#### **CITY COUNCIL RESOLUTION 2015-71**

## A RESOLUTION OF THE CITY COUNCIL OF THE CITY OF ALBANY, COUNTY OF ALAMEDA, STATE OF CALIFORNIA, APPROVING A MASTER SIGN PROGRAM AT 1080 MONROE STREET

#### ATTACHMENT 13 – Response to Ulan McKnight Appeal (filed 9/23/15)

6 FREESTANDING SIGN 3/8" = 1'-0"

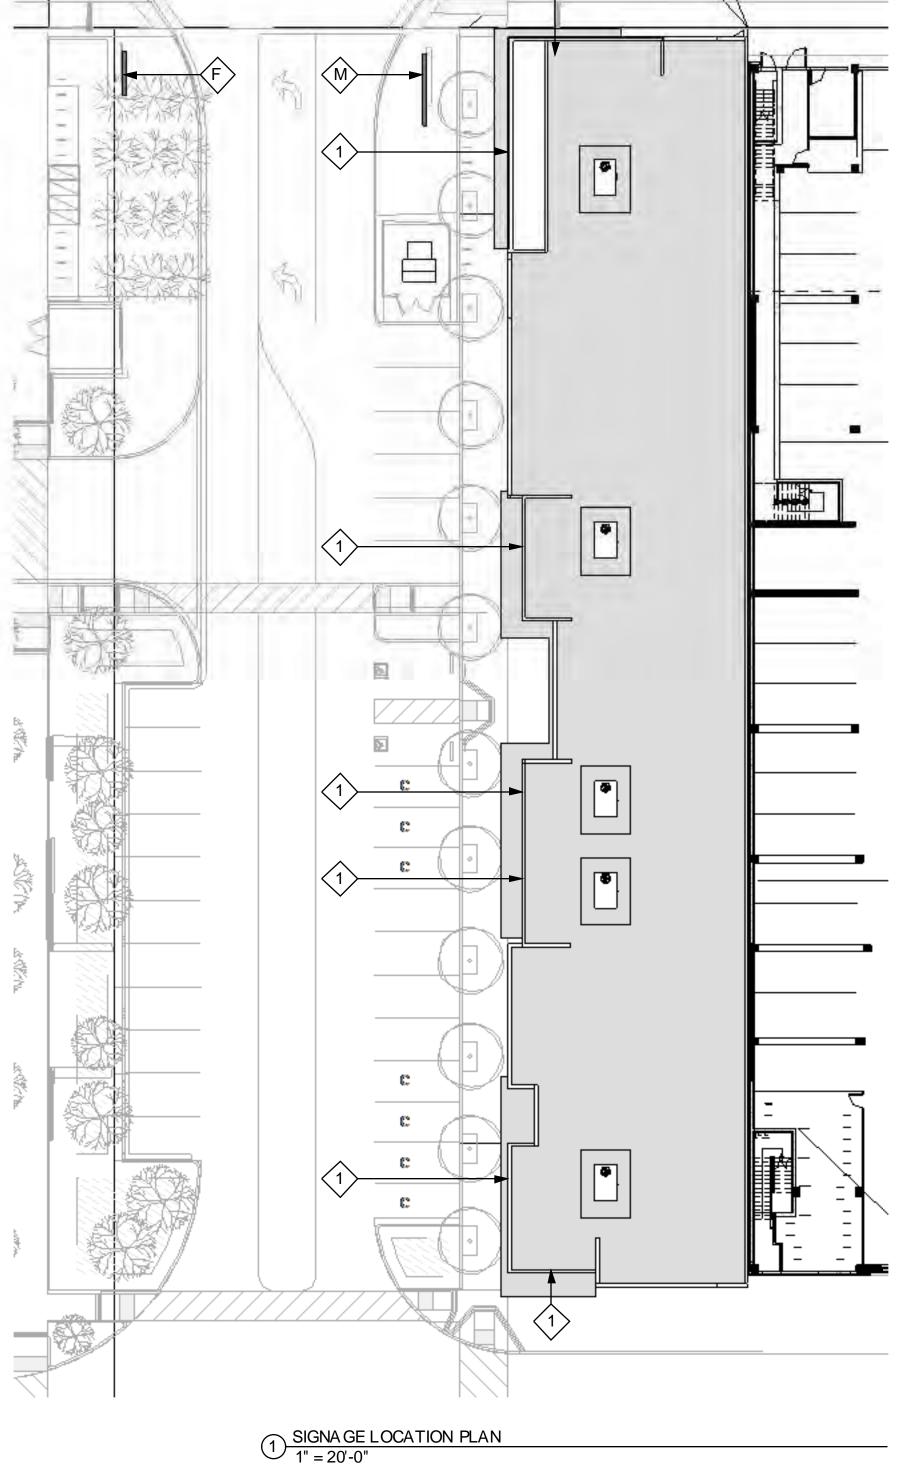
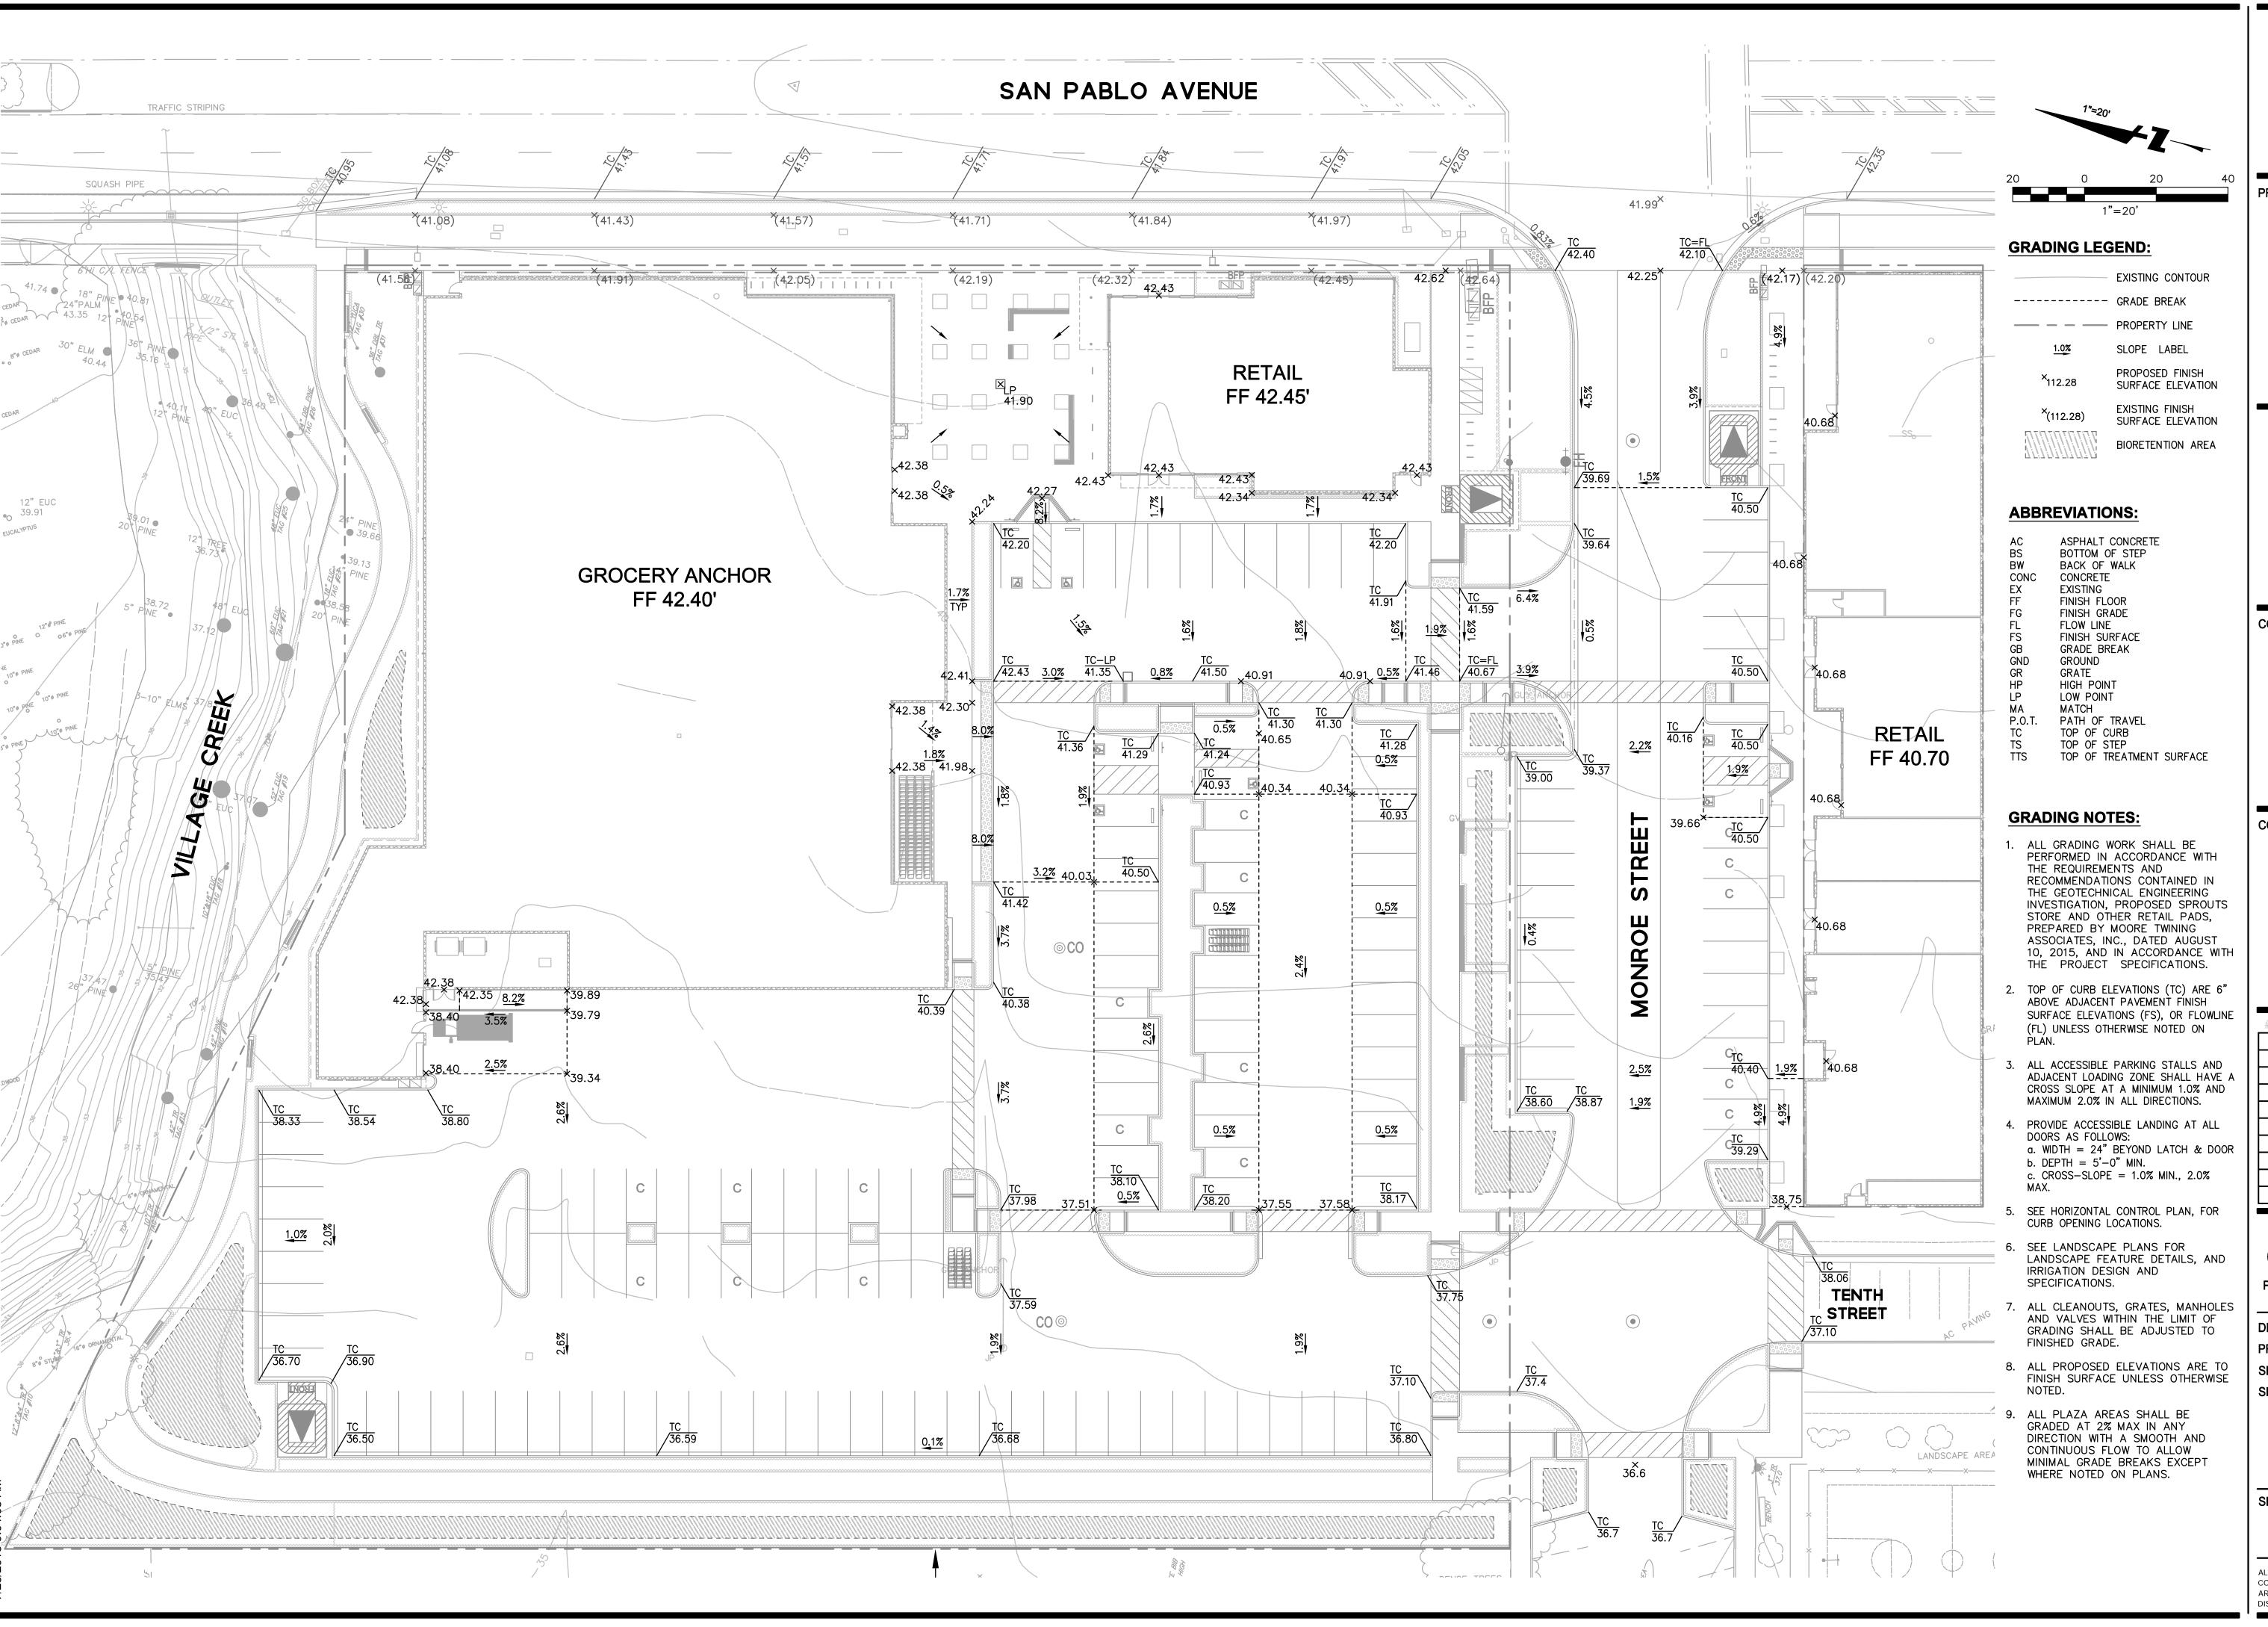
<u>Appeal Issue #4</u>: Project signage does not conform to Albany Municipal Code Section 20.32 for what is essentially a monument sign 10 feet in height; sign is not shown in plan view and not evaluated for potential obstruction of pedestrian and vehicle line of sight; signage is not located on the project site.

The appellant is correct that the proposed monument/freestanding sign was not shown in plan view; the applicant has provided a plan view of the sign on the plan set attached in Attachment 4 (Sheet A10.1). Staff shared the appellant's concerns about the visibility between drivers, bicyclists, and pedestrians at the corner of Monroe St. and San Pablo Ave. and as a result included the following condition of approval on the project. A clarifying edit is recommended as shown in strikeout/underline below.

The project applicant has continued to refine the sign proposal to meet City Code and has worked with Planning and Transportation Division staff to properly locate the sign to avoid obstructing sightlines for vehicles, bicyclists, and pedestrians. As shown in the plan set in Attachment 6 (Sheet A10.1), the current proposal is a freestanding sign proposed on two 2-foot
